Public Works Project No. 89006007-23-034-C1

I-70 WB Centerville Welcome Center  
INDOT

**ADDENDUM NO. 1**

October 1, 2024

Client Approval:

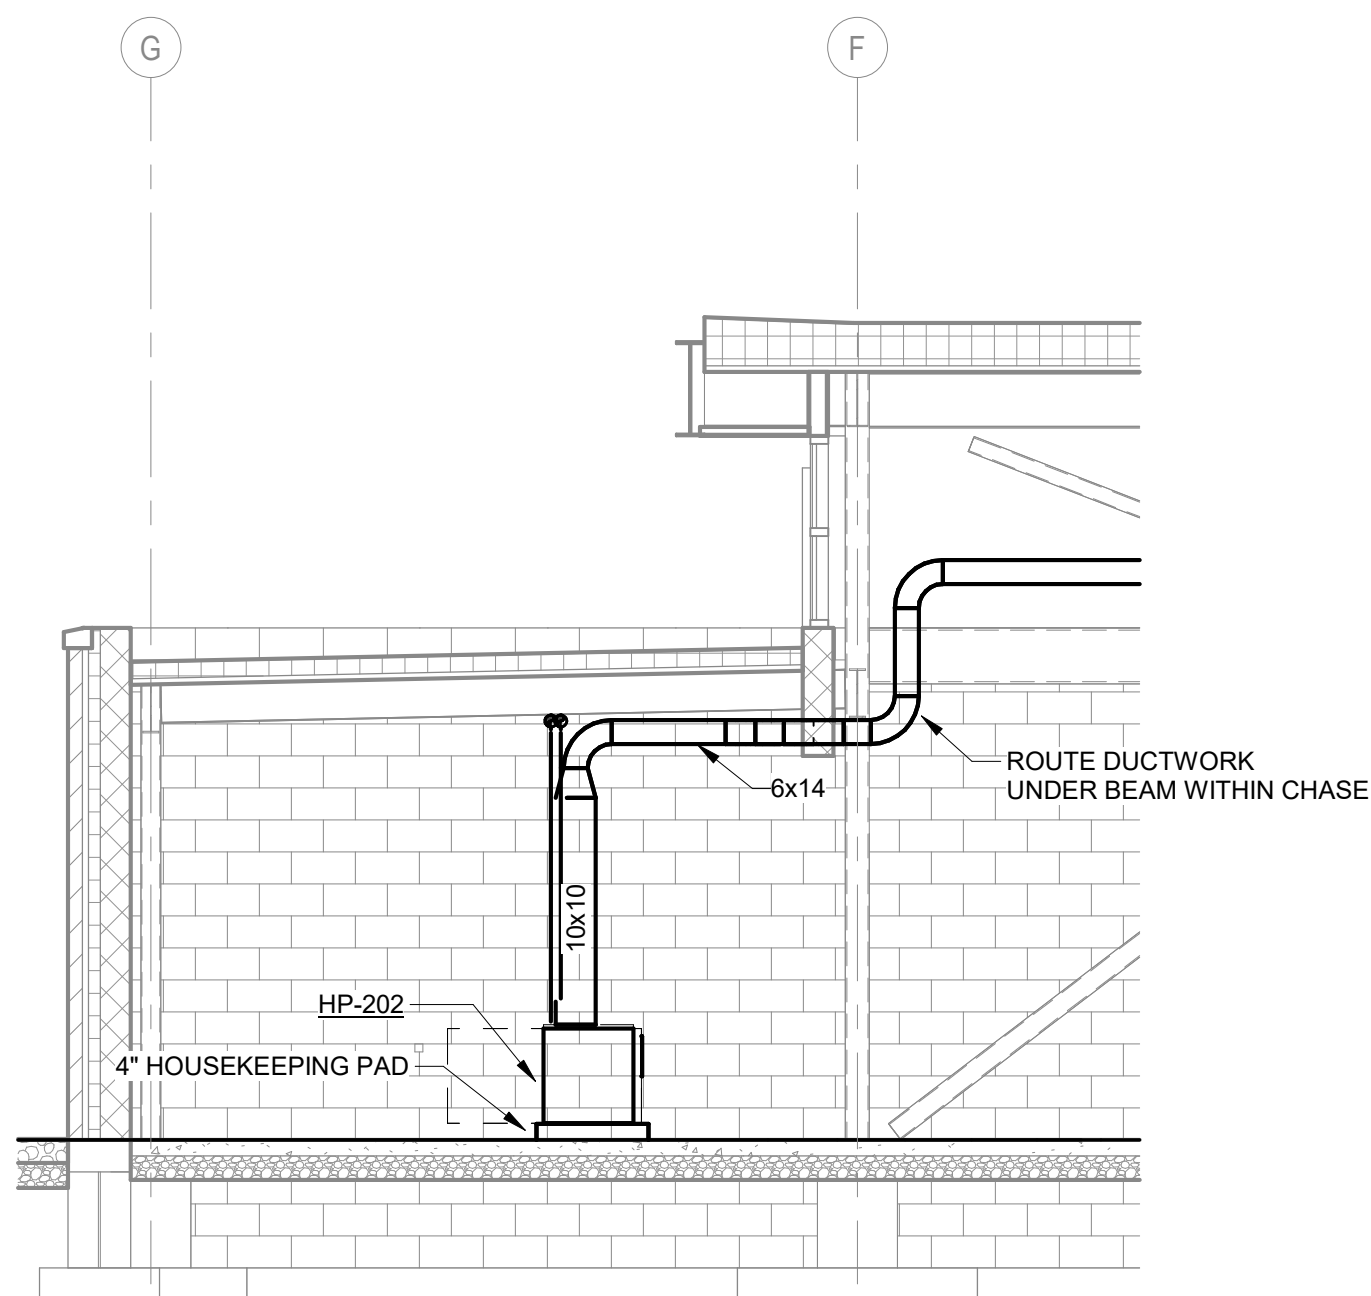
- Item No. 7-A1:**                    **Drawing Set #1, Sheet M3-1 WELCOME CENTER HVAC FLOOR PLAN**  
Replace:                                Replace Sheet M3-1 with attached Sheet M3-1  
Revise ductwork in mechanical room for better access to energy recovery ventilators. Change size and duct layout of HP-101.

Drawing Number: WC/P3-1

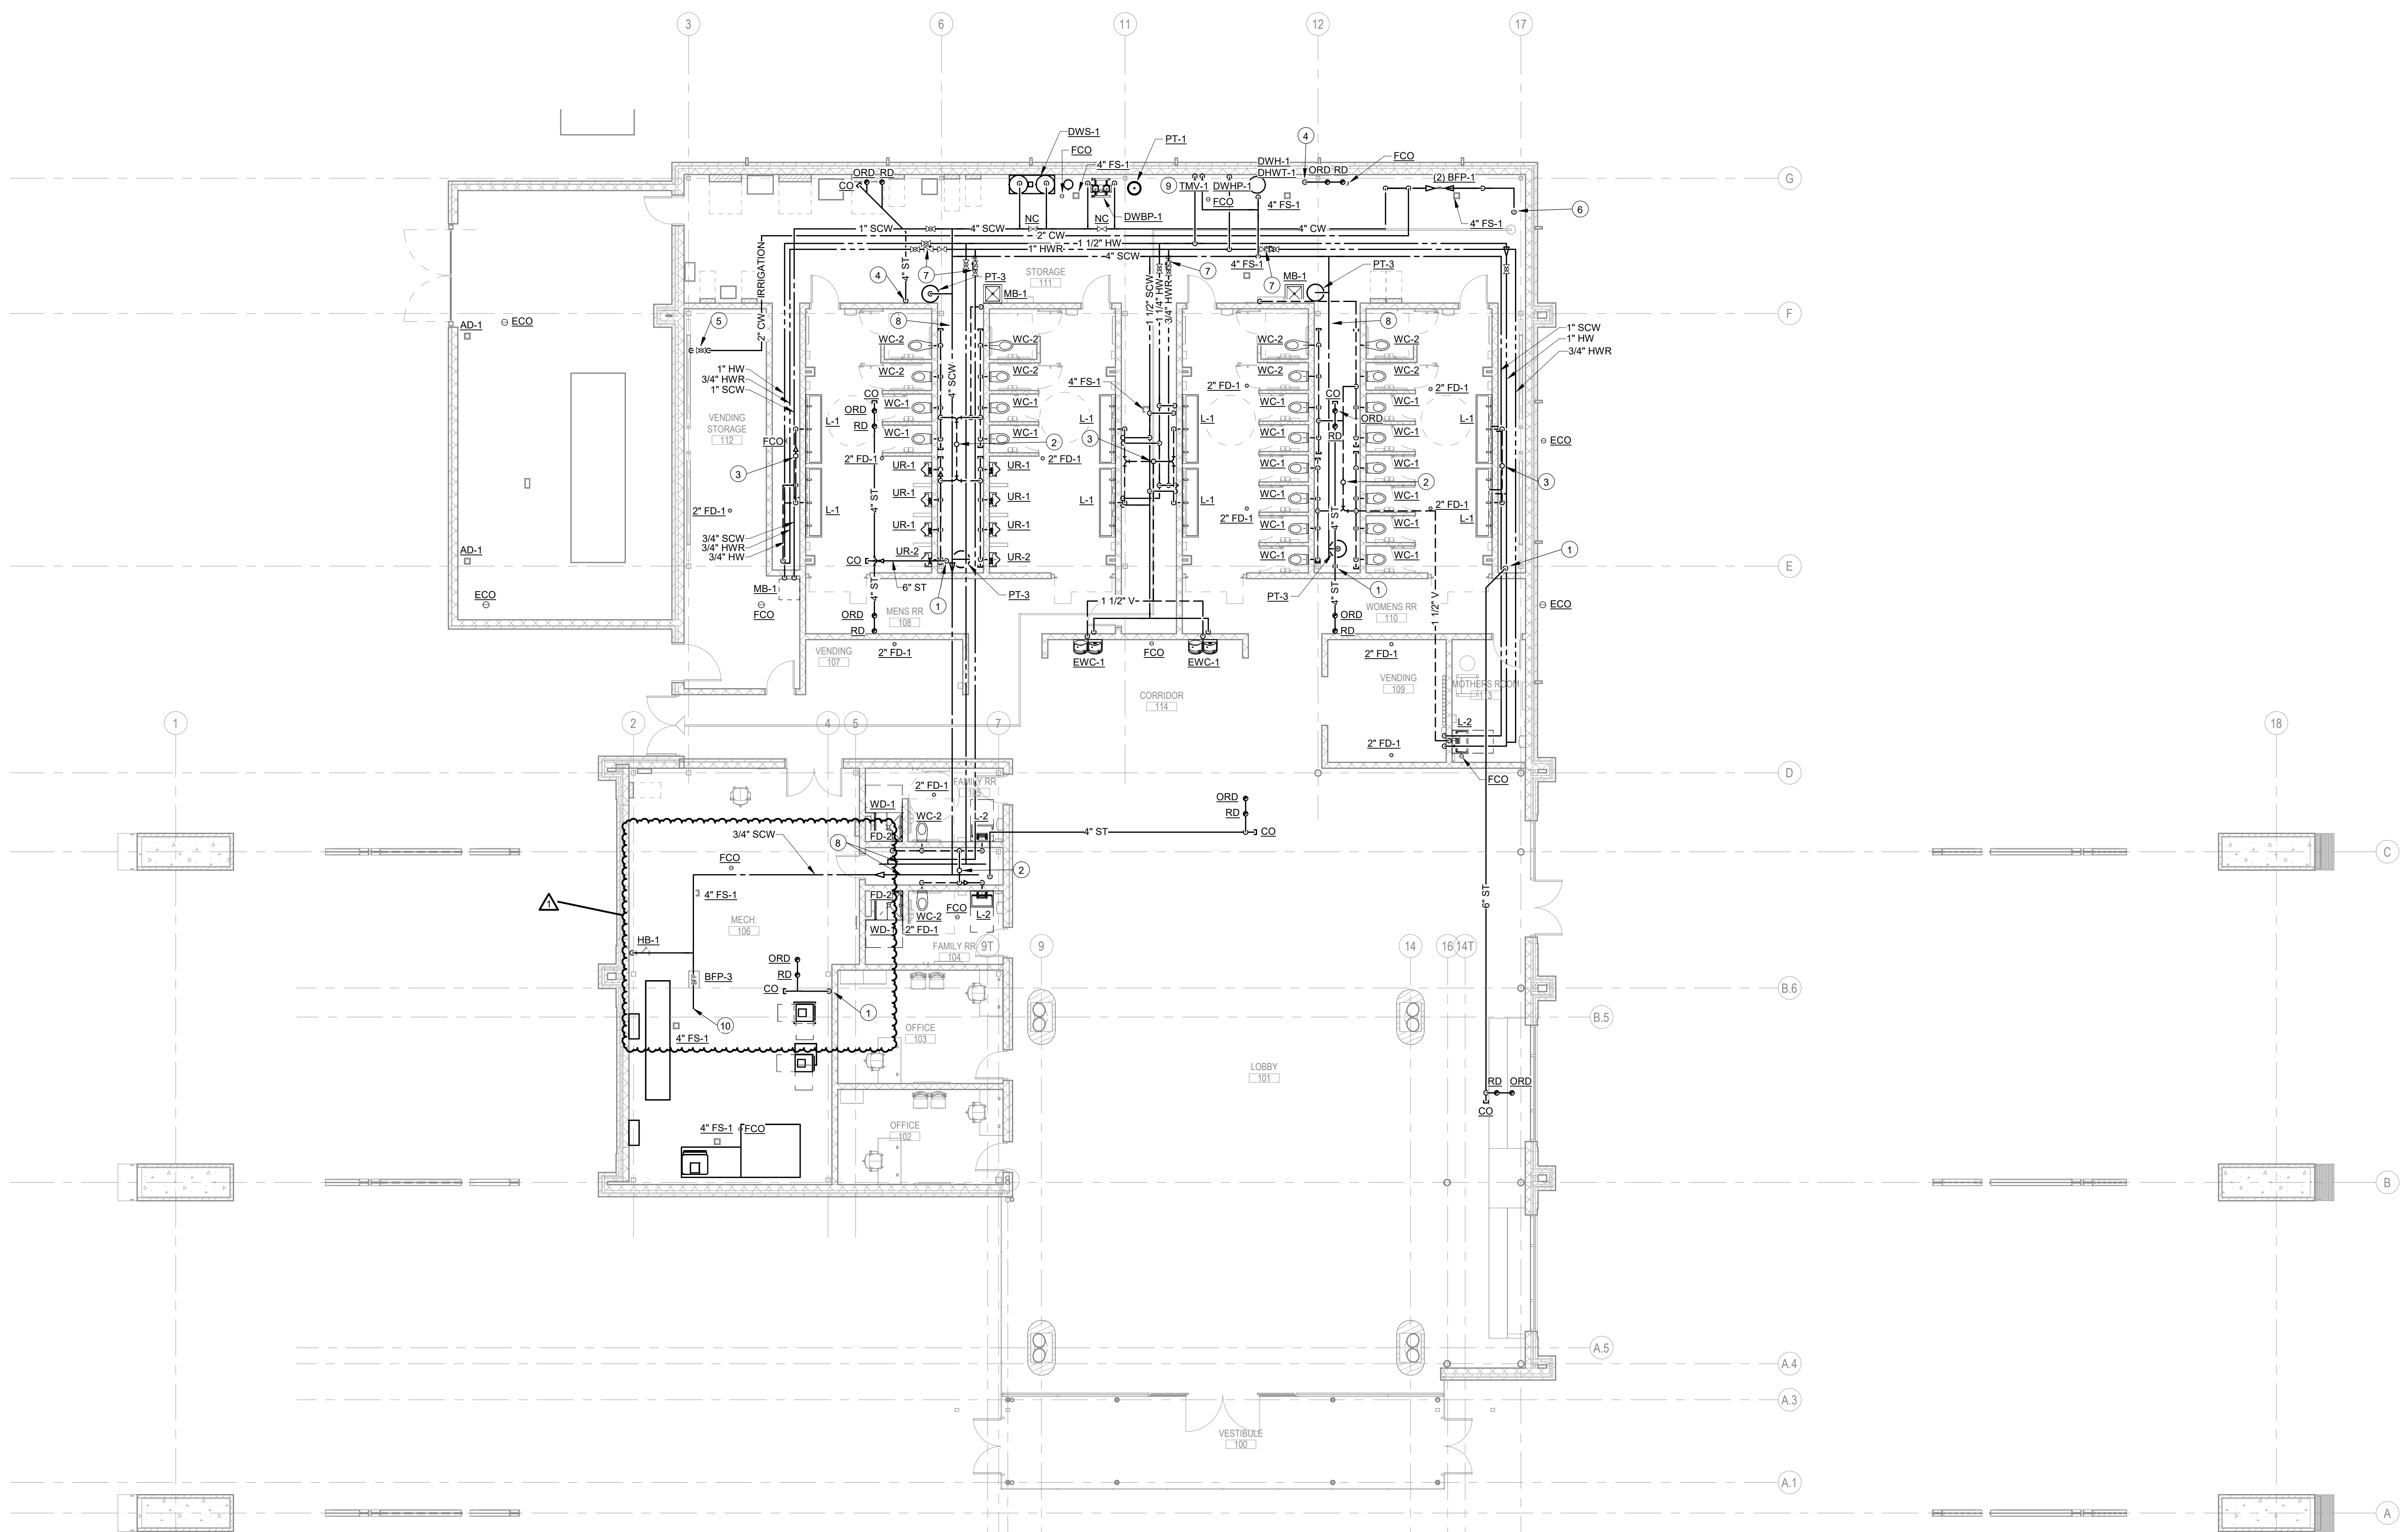
- Item No. 9-A1:**                    **Drawing Set #1, Sheet P3-1 WELCOME CENTER PLUMBING FLOOR PLAN**  
Replace:                                Replace Sheet P3-1 with attached Sheet P3-1  
Add water makeup and hose bib in Mech 106.

Drawing Number: TR/M1-2

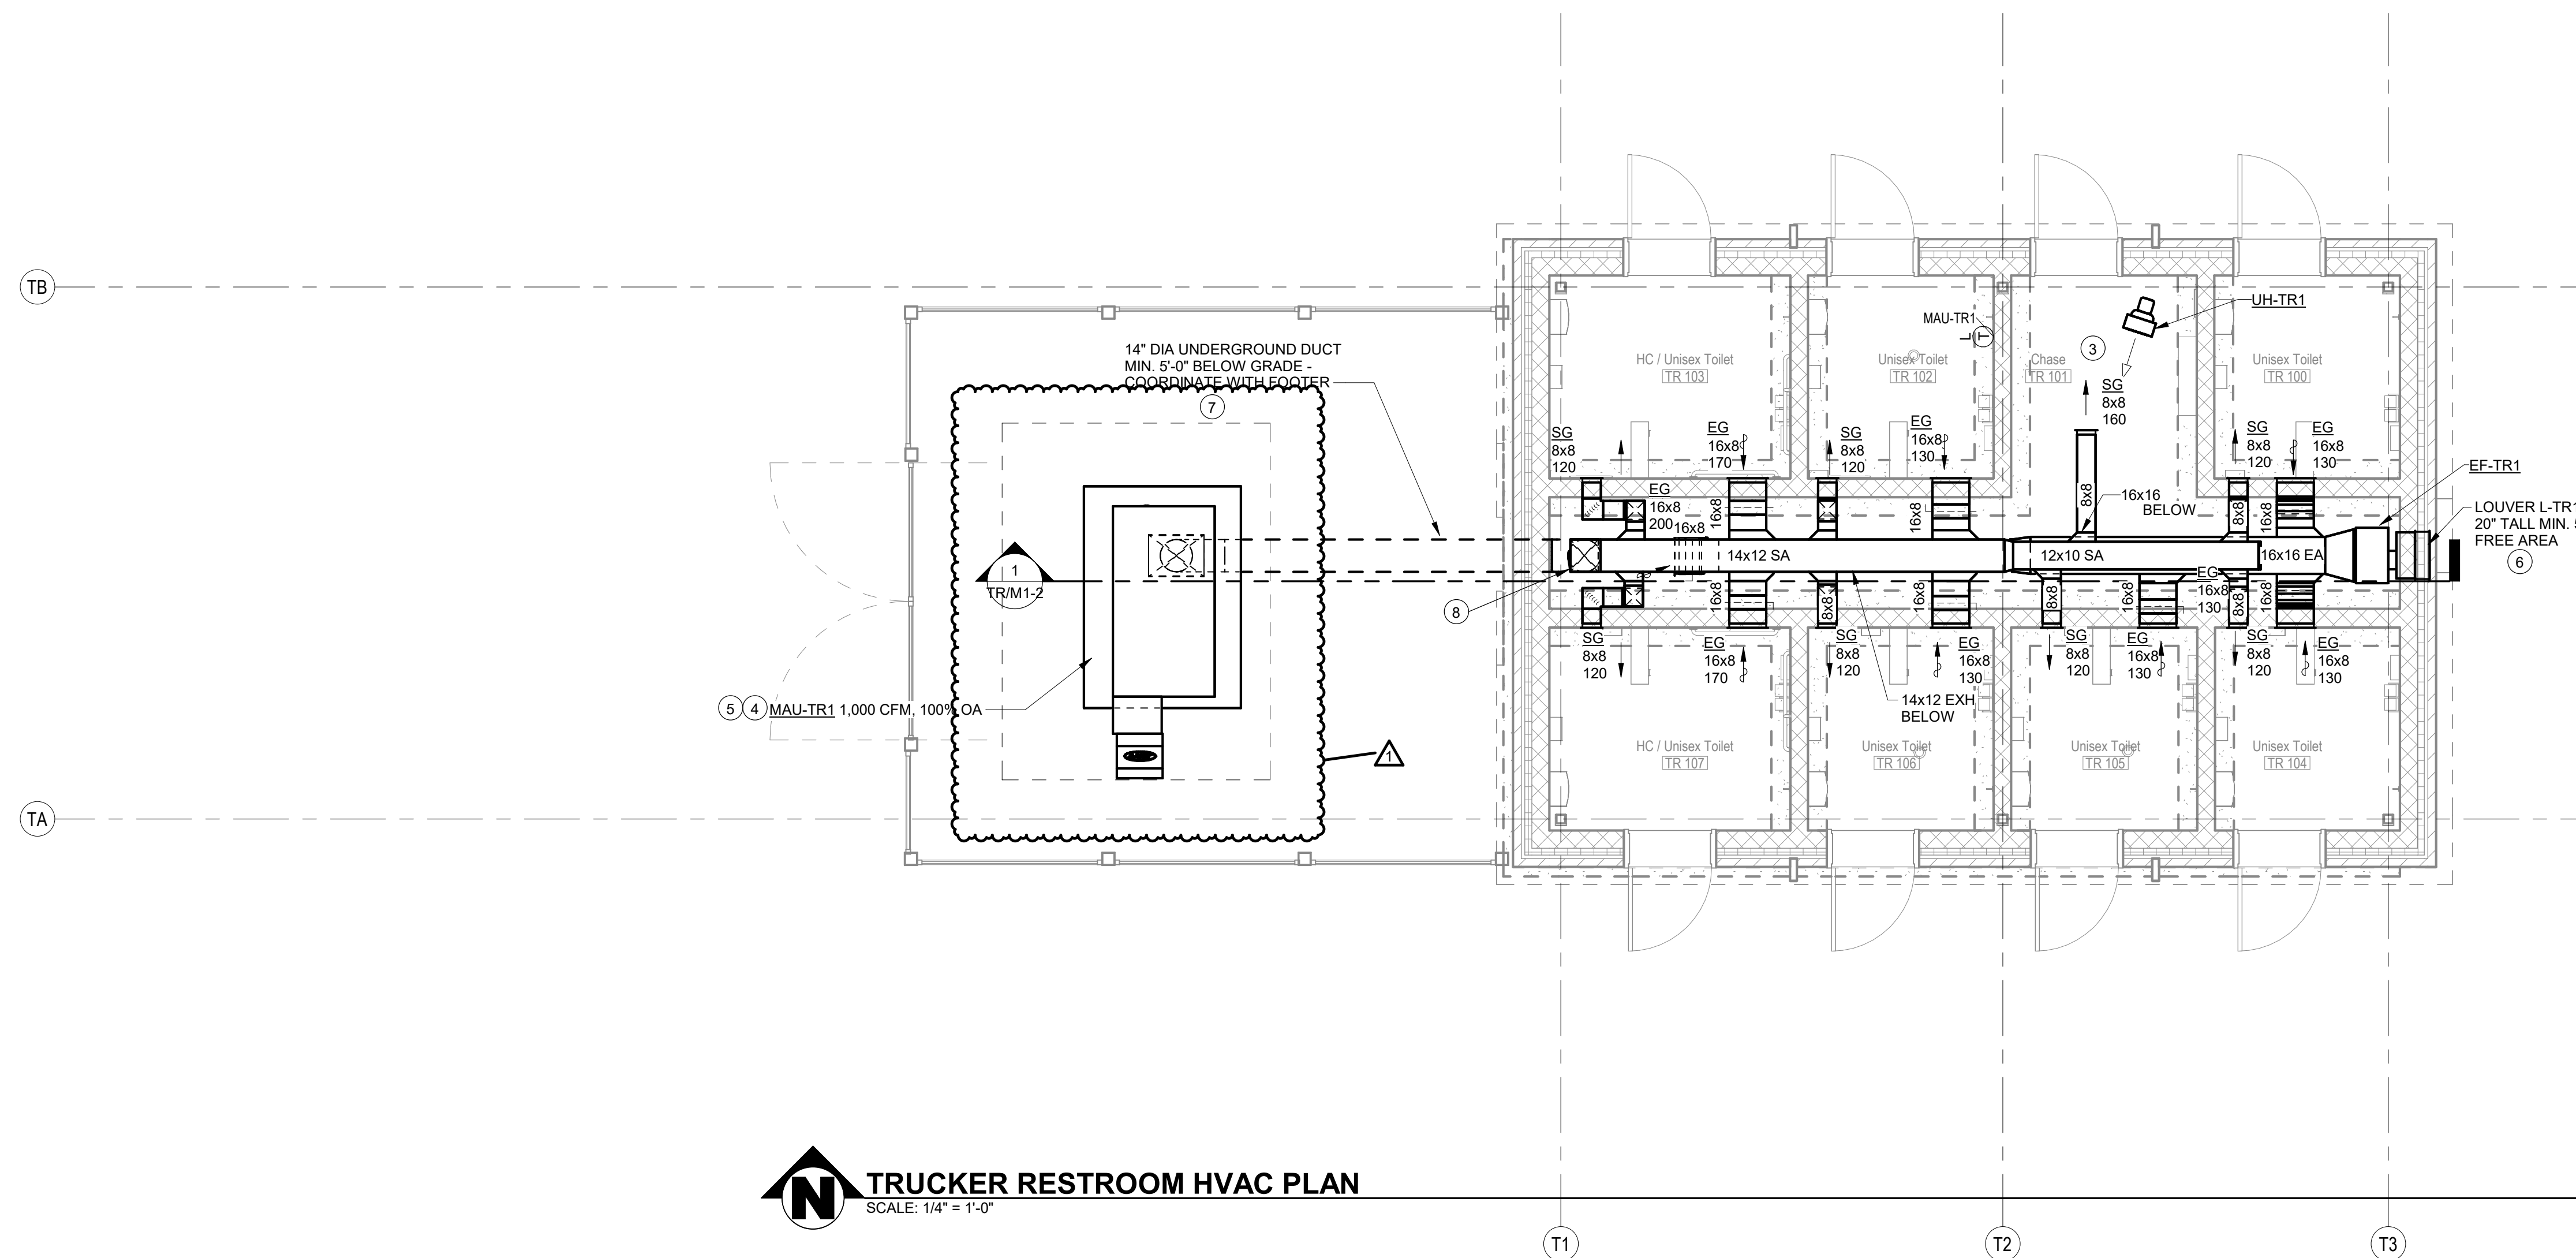
- Item No. 10-A1:**                    **Drawing Set #2, Sheet M1-2 TRUCKER RESTROOM HVAC PLANS**  
Replace:                                Replace Sheet M1-2 with attached Sheet M1-2  
Revise size and shape of MAU-TR1 to match changes related to R-454B refrigerant.
